WEBB WHEEL PRODUCTS, INC.

SERVICE BULLETIN (No. 19)

(NOTICE OF PRODUCT CHANGE)

HUB DESIGN

**Old Design
2023 Hub**

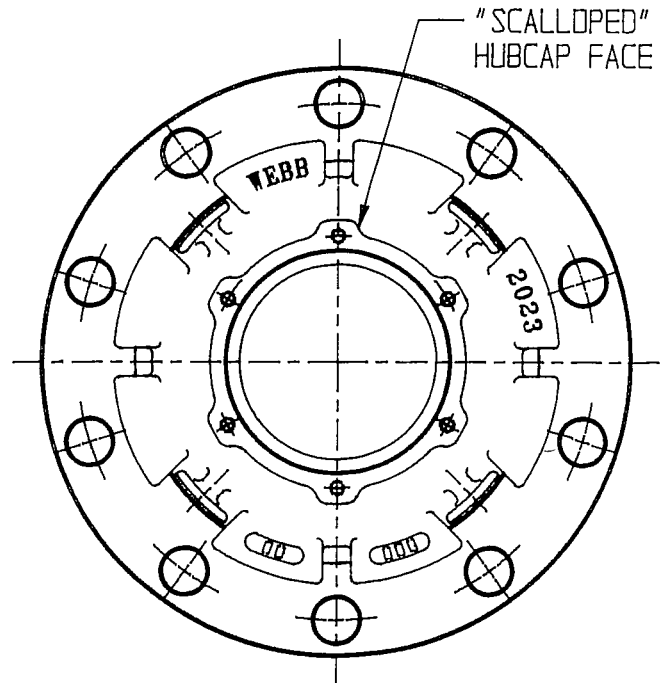
Although the current designs of our cast steel hubs have for years been considered an industry standard by many trailer manufacturers, we have implemented a design change which allows us to improve our foundry casting procedures and subsequently the weight of the finished product.

This change, while not affecting the well known advantages of our hubs, has caused a cosmetic change to the hub cap end of the hub only, as detailed below.

The new hub designs have been phased into production as form, fit, and function does not change. See reverse side for a sample assembly drawing.

**WEIGHT SAVING RESULTING
FROM DESIGN CHANGE**

**5 LBS.
7 LBS.**

**NEW DESIGN
WEIGHT**

**40 LBS.
39 LBS.**
